# **BLOCK 5 POCKET PARK**

**DESIGN DEVELOPMENT**

**SEATTLE DESIGN COMMISSION | 6 JUNE 2019 | SITE WORKSHOP**

## SDC MEETING 09/07/17

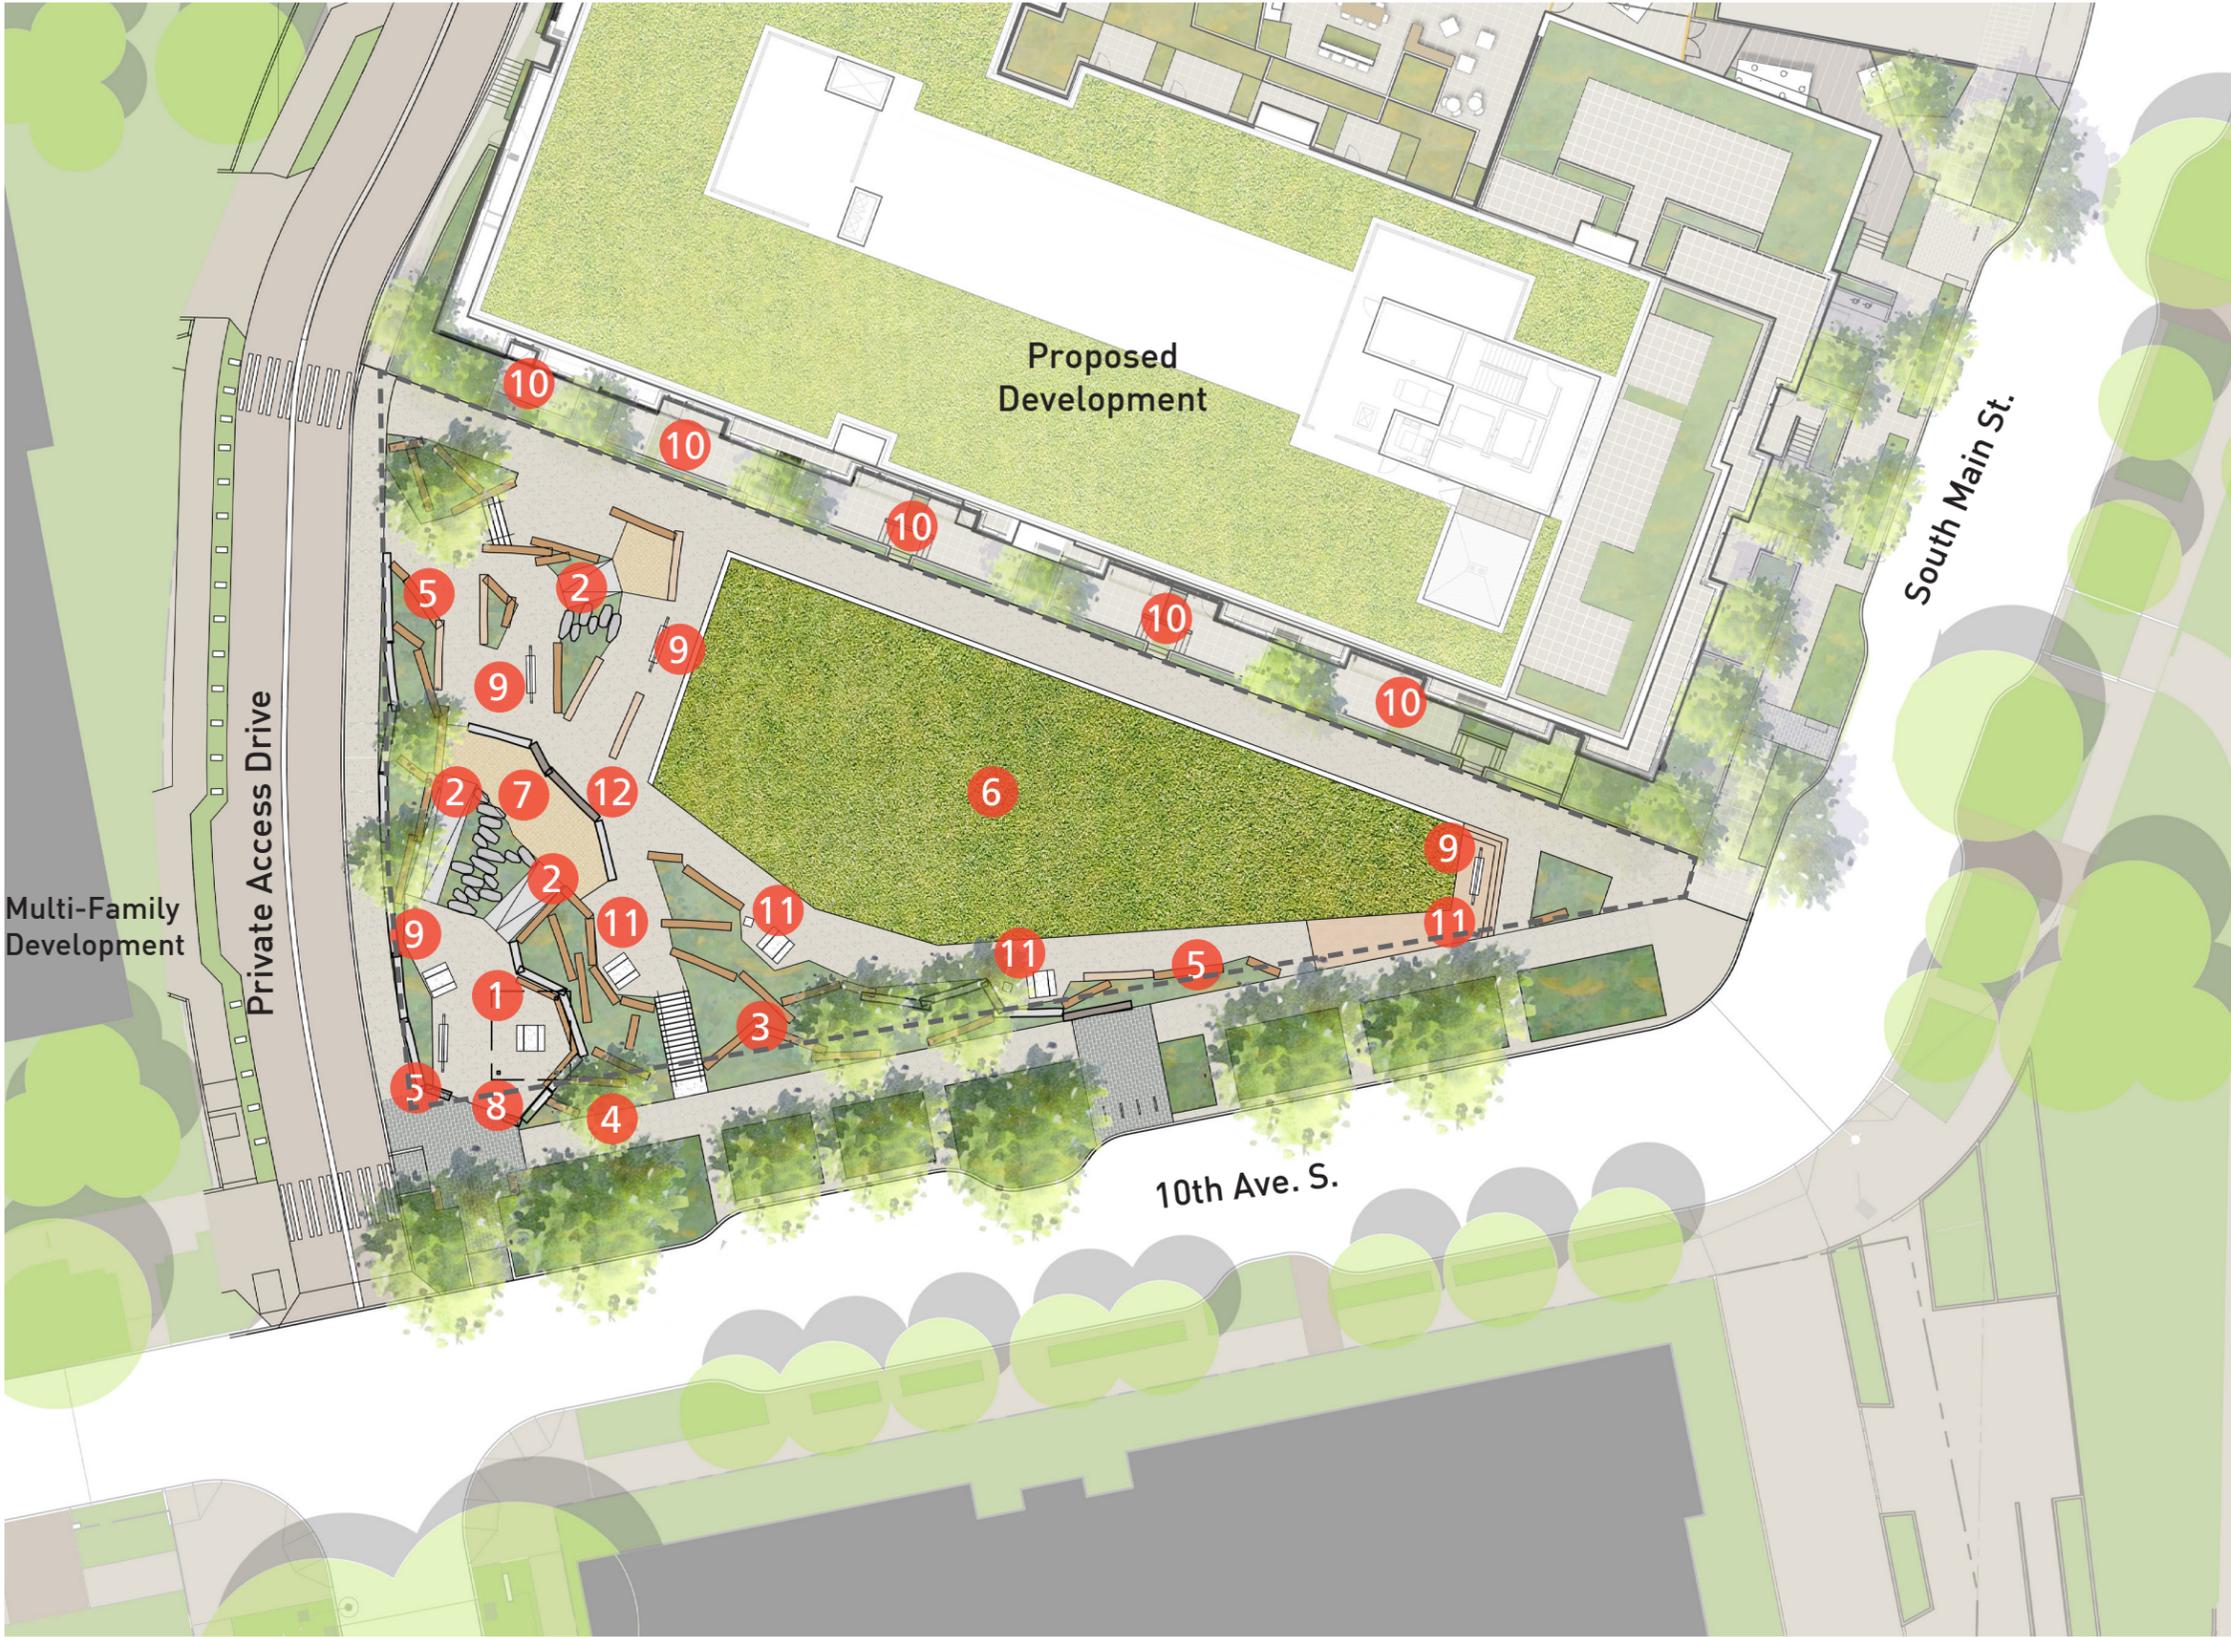
- 1 General approval of reorientation of the park development
- 2 Concern with proposed stairway along central pathway - circulation and accessibility
- 3 Consider wayfinding elements to orient users
- 4 Consider buffer area between park and adjacent residential entrances
- 5 Consider removing pavilion at southern corner – integrate northern pavilion to garden play area
- 6 Consider increasing size of open lawn

### **PREFERRED**

- Single lawn
- Garden play
- Up/down play
- Connections
